MIL-E-24403A(SH)
 AMENDMENT 1
 30 August 1983

ELECTRODES - WELDING, FLUX CORED, GENERAL SPECIFICATION FOR

This amendment forms a part of MIL-E-24403A(SH), dated 21 December 1981, and is approved for use by the Naval Sea Systems Command, Department of the Navy, and is available for use by all Departments and Agencies of the Department of Defense.

FIGURE 3. Details of stringer bead test assembly for the preparation of diffusible hydrogen test specimens for the gas chromatography method.

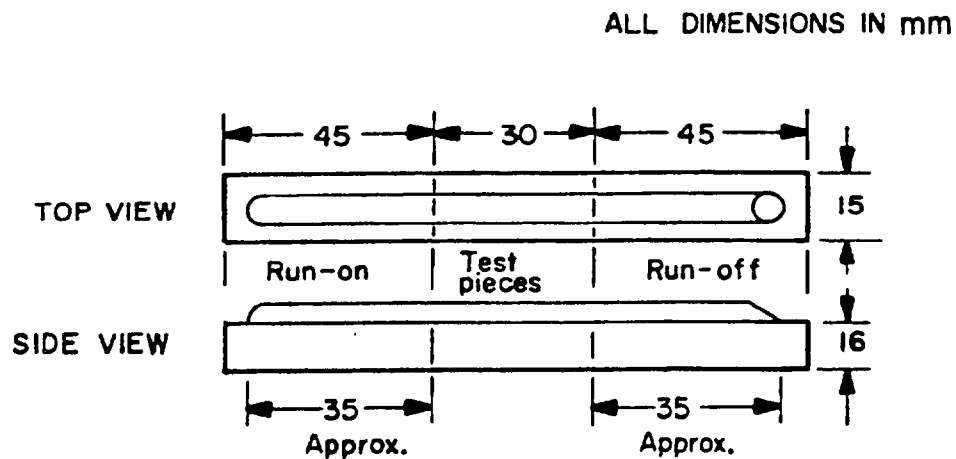
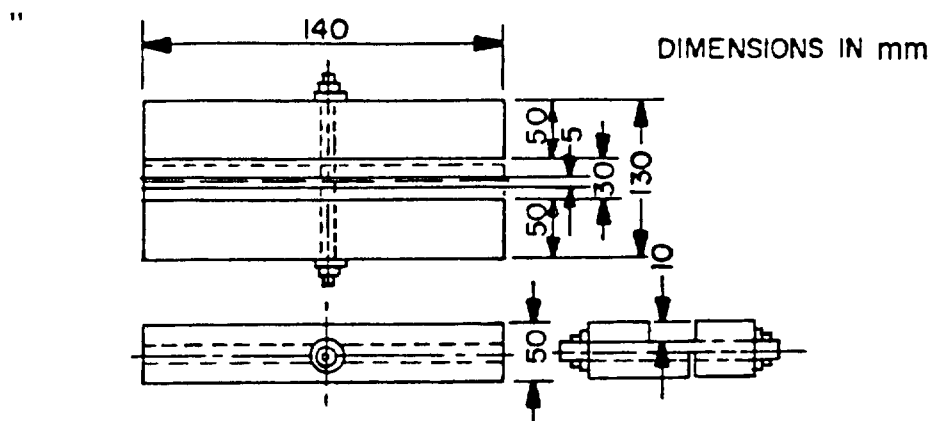
Figure 3 and notes: Delete and substitute figures 3, 4 and 5:

Test assembly for electrodes larger than 1/16-inch,
provides two diffusible hydrogen test specimens.

Test assembly for electrodes 1/16-inch and smaller,
provides one diffusible hydrogen test specimen.
